Application for Downhole Commingling of Fruitland Coal and Pictured Cliffs

San Juan 29-7 Unit #520 (SW Section 8, T-29-N, R-7-W) San Juan 29-7 Unit #584 (NE Section 6, T-29-N, R-7-W)

Downhole Commingling Applications

San Juan 29-7 Unit Well Nos.520 & 584

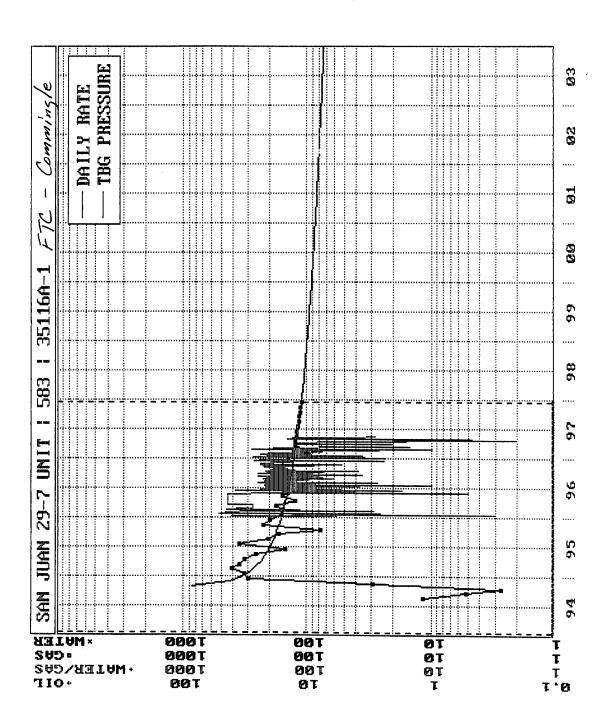
The San Juan 29-7 Unit #520 well is offset to the west by the San Juan 29-7 Unit #547 and #548 in Section 7. They also lie in the underpressured fairway and show no incline in their profiles. The San Juan 29-7 Unit #583 well in Section 6 is a Pictured Cliffs-Fruitland Coal commingle and the subtraction formula results in an allocation to the Fruitland that produces a conventional decline rate. Conversely, the San Juan 29-7 Unit #519 well (also a Pictured Cliffs-Fruitland Coal commingle) shows a decline rate due to the allocation formula that is consistent with an overpressured, inclining profile. Other offsets, the San Juan 29-7 Unit #534, #544, and #546 show inclining initial rates consistent with being in the overpressured fairway.

SAN JUAN 29-7 UNIT #584 T29N, R7W, SEC. 6 G, RIO ARRIBA COUNTY, NM FRUITLAND COAL

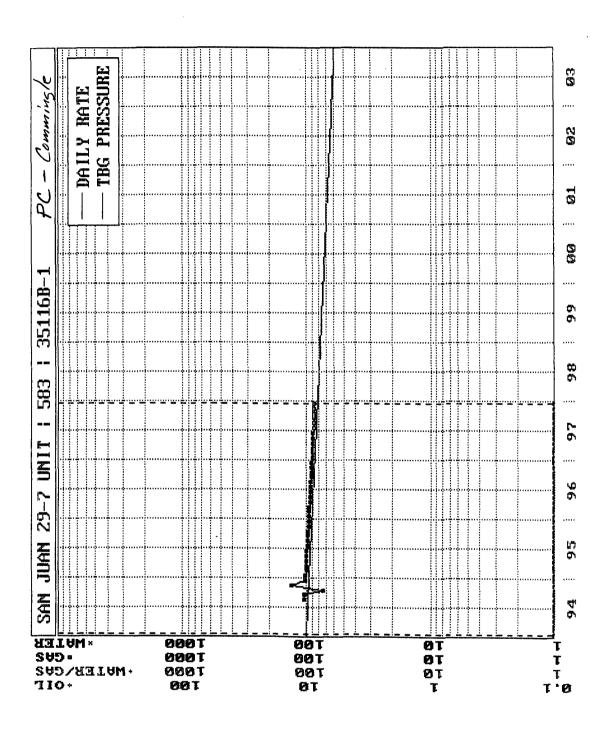
Offsetting data for the San Juan 29-7 Unit #584 is similar to the above for the #520, as shown on the attachments. It should be noted that the supporting decline curves are only provided for Burlington operated wells.
